**Agenda - Council - July 27, 2005**

**Report - Standing Policy Committee on Property and Development - July 18, 2005**

**Item No. 1 Subdivision and Rezoning - east of Main Street, south of Commonwealth Avenue [Greenview Homes (Manitoba) Ltd.] File DASZ 10/2005**

**Date:** **June 6, 2005**
**File:** **DASZ 10/05**
**Related Files:** **DASZ 10/05, DCU 05-114829D, DAV 05-132231D**
**Subject:** **An application has been received from Dave Palubeski, Lombard North Group for approval of a plan of subdivision and related zoning change to Zoning By-Law No. 6400/94 by rezoning the subject lands from a "R1-20" Residential District to "R1-4" Residential District and "PR-1" Parks and Recreation District to allow for the creation of single family lots and public reserve land.**

**Figure 1: Approximate Area of River Bottom Forest**

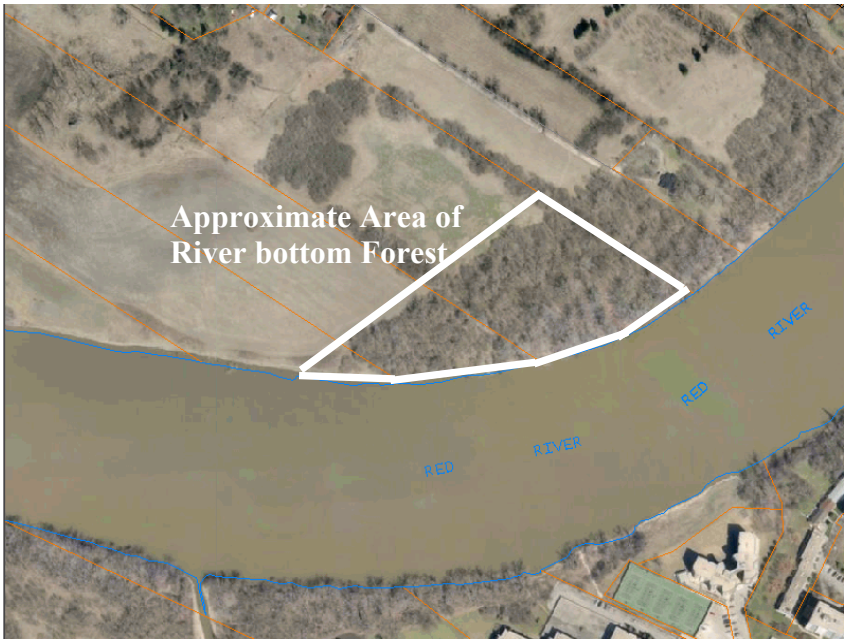
The entire river bottom forest area identified for preservation measures 6.5 acres. If this area were taken in its entirety for dedication, it would amount to an overall dedication of 10.5%.

The applicant has proposed to preserve a portion of the area, approximately 4.3 acres, and to develop the remaining portion. He indicates that he is not prepared to provide a further dedication of the river bottom forest area without compensation from the City, in the form of either a cash payment or a waiver of certain obligations under the development agreement.

**Revised Schedule "A" to the report to the Lord Selkirk-West Kildonan Community Committee for File No. DASZ 10/05 dated June 16, 2005**

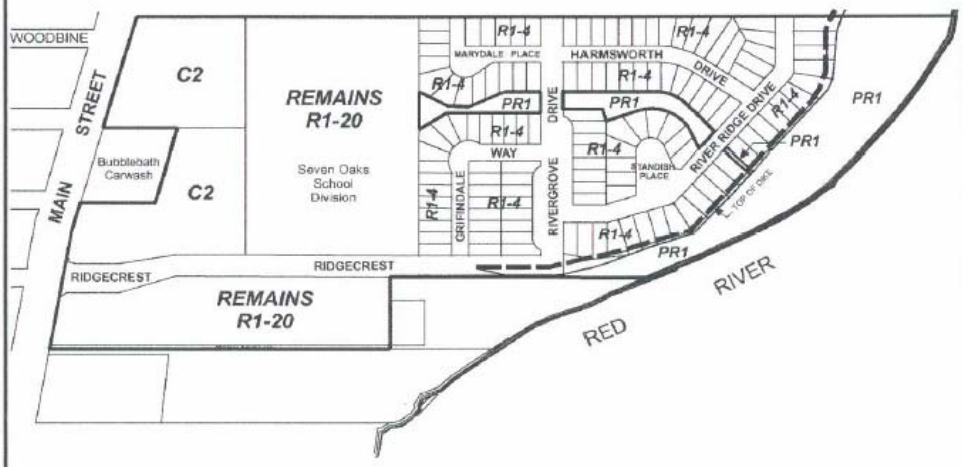
- That in recommendation 1, the word "revised" be added in front of the words "Schedule A" and the date of the Schedule "A" be changed to read "June 16, 2005".

- That in recommendation 3, the word "revised" be added in front of the words "Schedule A" and the date of the Schedule "A" be changed to read "June 16, 2005".

**Appendix 5:**
**Proposed dedication for public reserve.**
**(The dashed area is river bottom forest requested by the City for dedication.)**

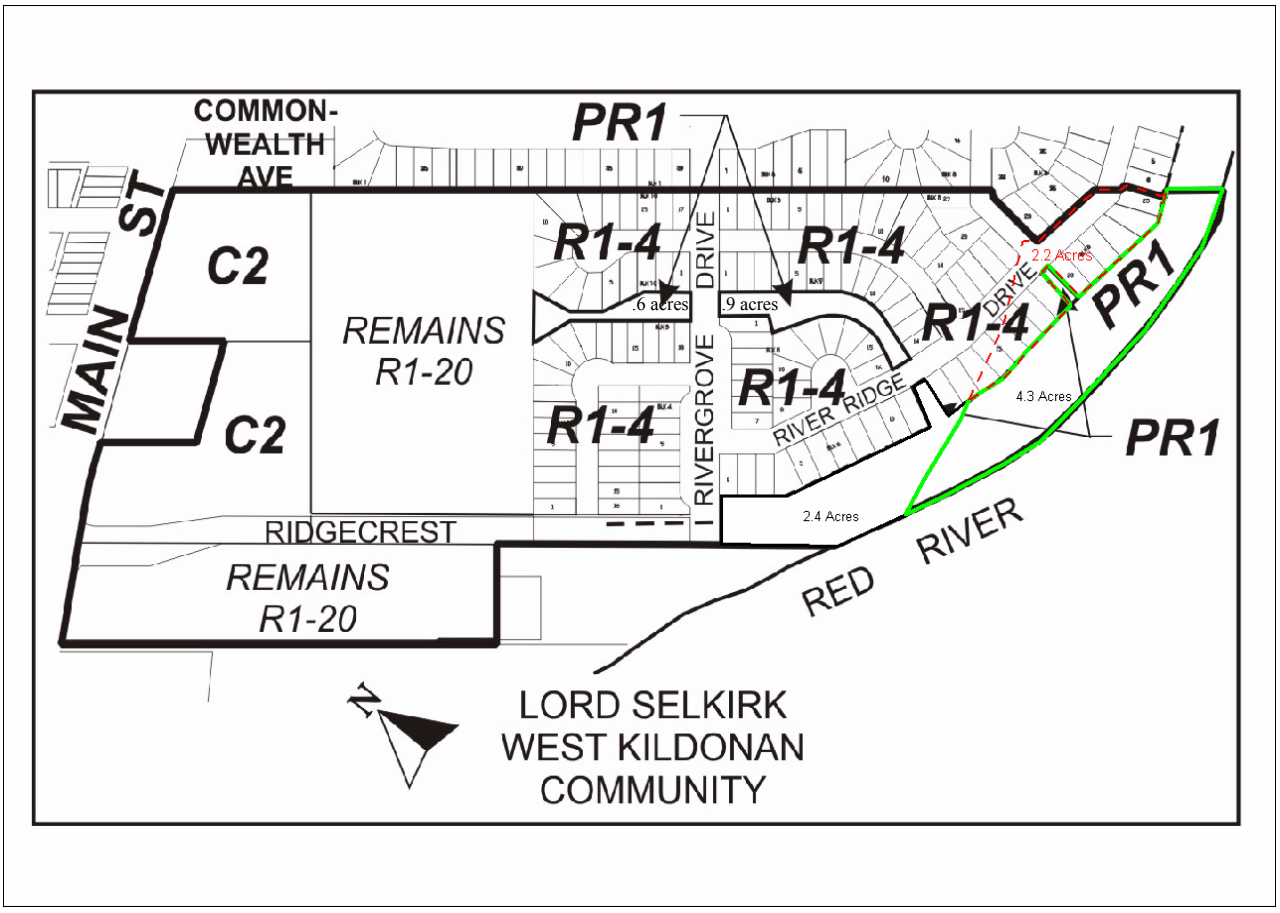
The Planning and Land Use Division has reviewed their requirements for open space in the area and has indicated that these additional lands are not needed. If the applicant chooses to provide the pathway as an additional amenity for future residents and students, it will be supported and encouraged by the City and would be accepted and maintained as public reserve. However, it is not a requirement of this development.

Similarly, the land to the south of the river bottom forest is not required and will provide little benefit to the City, with the exception of a pathway, which can also be accommodated without actual ownership through an easement. This area is heavily eroded and may continue to experience additional erosion in the future without stabilization measures. This, coupled with the fact that the dike footprint will encroach on the majority of this land leads to the conclusion that this land is of little value to the City and would be better utilized in the ownership of the private lots abutting this property – with an easement to be maintained along the river for a pathway.
